Mixed Low-Level Radioactive and Hazardous Waste Disposal Facilities

Review and Comparison by
John R. Brodeur, P.E., L.E.G.
Energy Sciences & Engineering
Kennewick, WA

Comments on Hanford
Facilities & Background
Prepared by
Heart of America Northwest
1314 NE 56th St., #100
Seattle, WA 98105

March 2006

Fig. 3.2 ERDF Disposal Cells

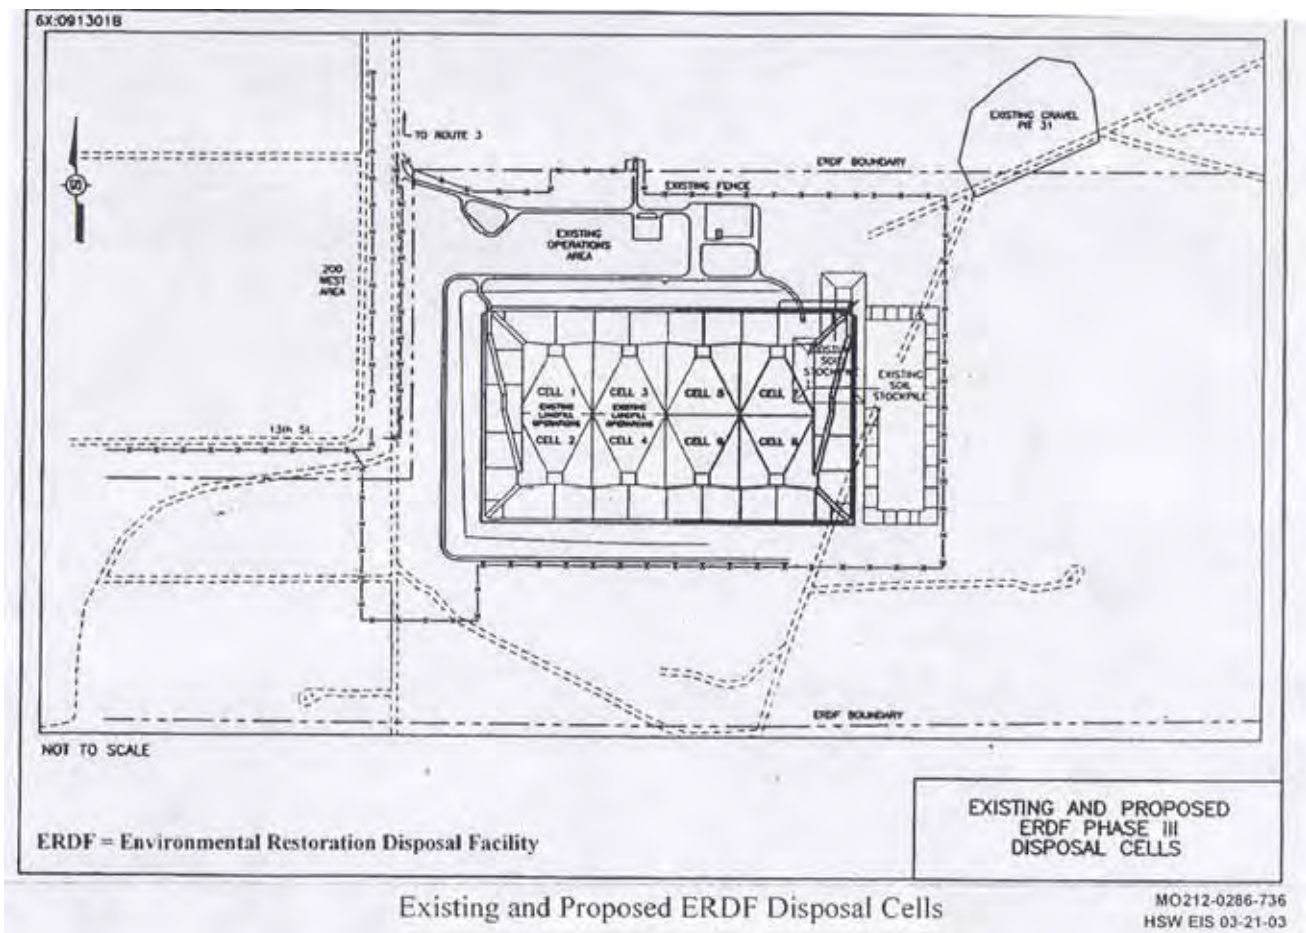
The ERDF design and construction details are found in the conceptual design report (USACE, 1994) and in the construction specifications (USACE, 1995). General design requirements for the ERDF are found in the Record of Decision (EPA, 1995). Detailed design and operations procedures exists for the facility but they were not available for this review.

Fig. 3.2.2

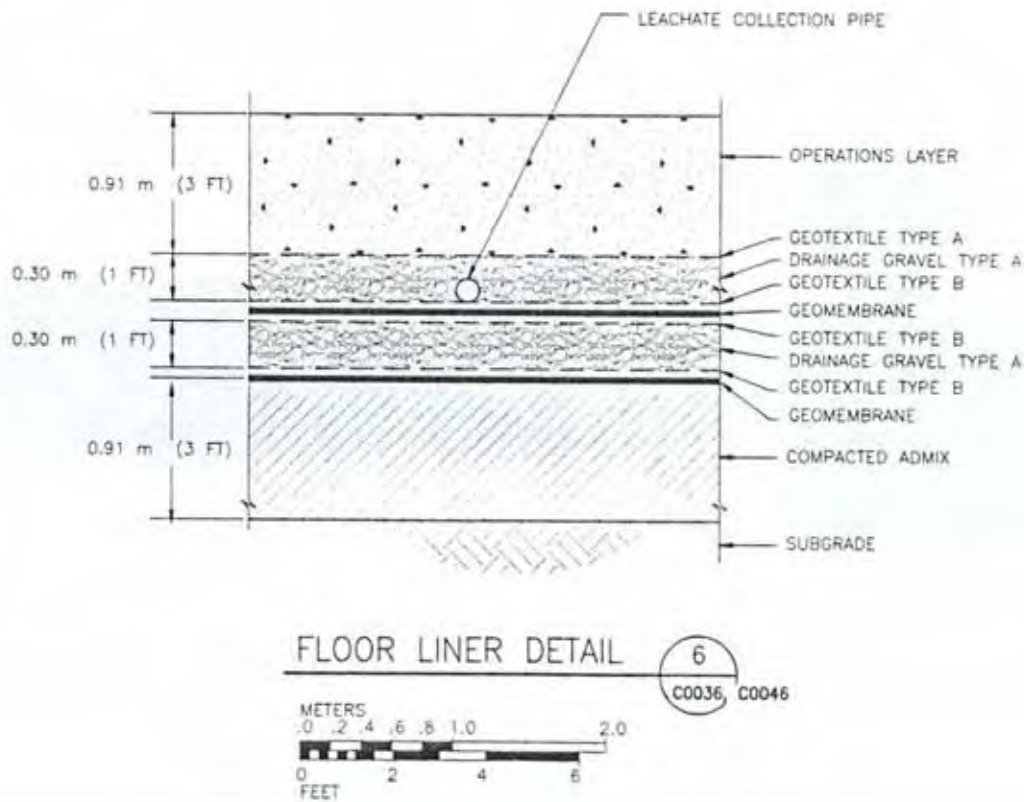
The liner was then constructed on top of the compacted sub grade. A schematic of the ERDF liner is shown in Figure 3.2.2.

All liner materials including the geomembranes, geotextiles, soils and gravel layers, have material specifications and tolerances listed in the construction plan. All liner materials and layers are placed according to specific requirements and then tested to assure compliance with specifications. In this manner, all components of the liner system are engineered and the construction methods and quality are controlled.

Fig. 3.2.3 Typical Hanford Site Landfill Cover Design

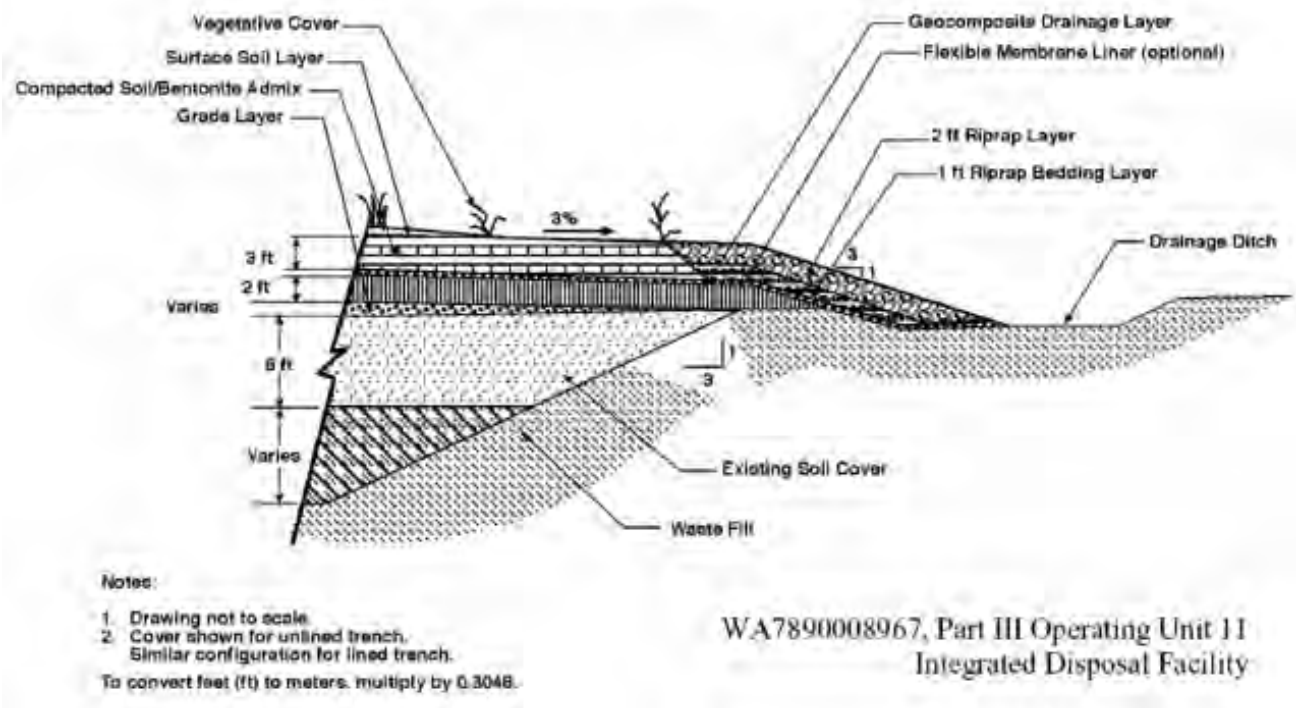
The cover system design has not yet been finalized. However, the ROD indicates that the cover will be either a RCRA compliant cover or a modified RCRA cover. The modified RCRA cover adds features such as a layer of rip-rap rock to help deter intrusion into the waste and features such as an infiltration barrier designed to enhance evapotranspiration in the Hanford climate.

Fig. 3.3 Integrated Disposal Facility Site Plan

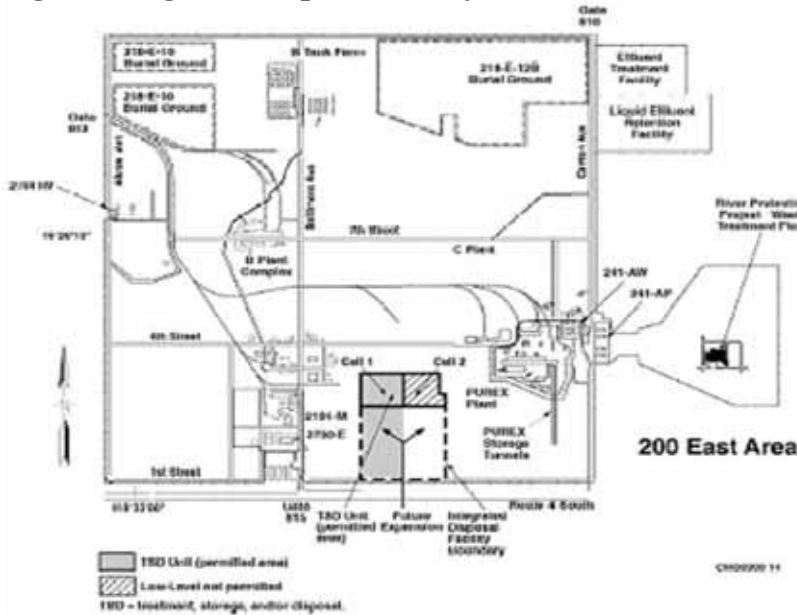
The USDOE’s proposed Integrated Disposal Facility (IDF) is currently under construction in the 200 East Area at Hanford (see Figure 3.3). This facility is a combination of two identical disposal cells sitting side-by-side and referred to as the East Cell and the West Cell. Figure 3.3 provides the only site plot that could be found for the IDF because maps and schematics were redacted from the Ecology permit application (presumably due to USDOE request for security controls intended to mitigate terrorist threats to the facility). This inexplicable redaction of siting and design adds to the difficulty of getting information on this facility, and makes commenting on the permit and impacts more difficult.

The IDF is to be 900,000 cubic meters total volume (31,77 million cubic feet, or 1.2 million cubic yards). It will be constructed as a moving waste disposal pit similar to the ERDF, with the initial pit in the north portion and a service ramp toward the south. This allows filling of the North portions first with expansion toward the south to eventually cover the entire footprint area shown in Figure 3.3.
